2004 - 2009 Cadillac XLR: Service Bulletin: #01-07-30-032E: Transmission Oil Leaking From Transmission Vent

#01-07-30-032E: Transmission Oil Leaking From Transmission Vent (Replace Transmission Case Cover (Channel Plate) Gasket) - (Sep 29, 2008)

Models: 1997-2009 GM
Passenger Cars and
Light Duty Trucks
(including Saturn)

with Hydra-Matic
4T65-E Automatic
Transmission (RPOs
MN3, MN7, M15, M76)

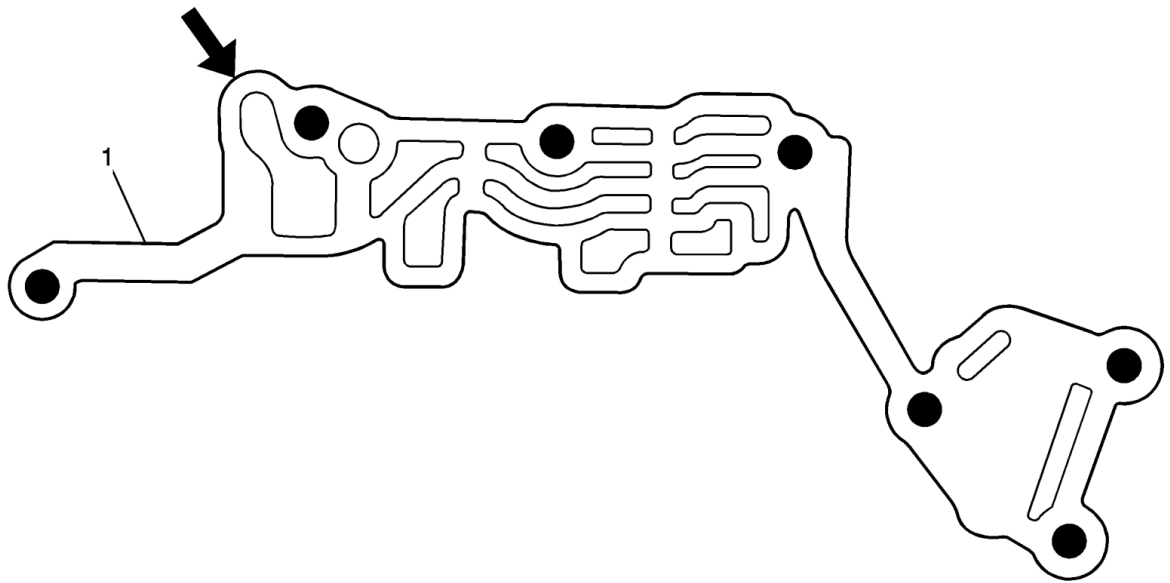
Visual inspection of the upper gasket (1) will reveal damage at the referenced area.

To correct this condition, replace the case cover (channel plate) gaskets (429 and 430). Refer to Unit Repair publication in SI of the appropriate vehicle being serviced.
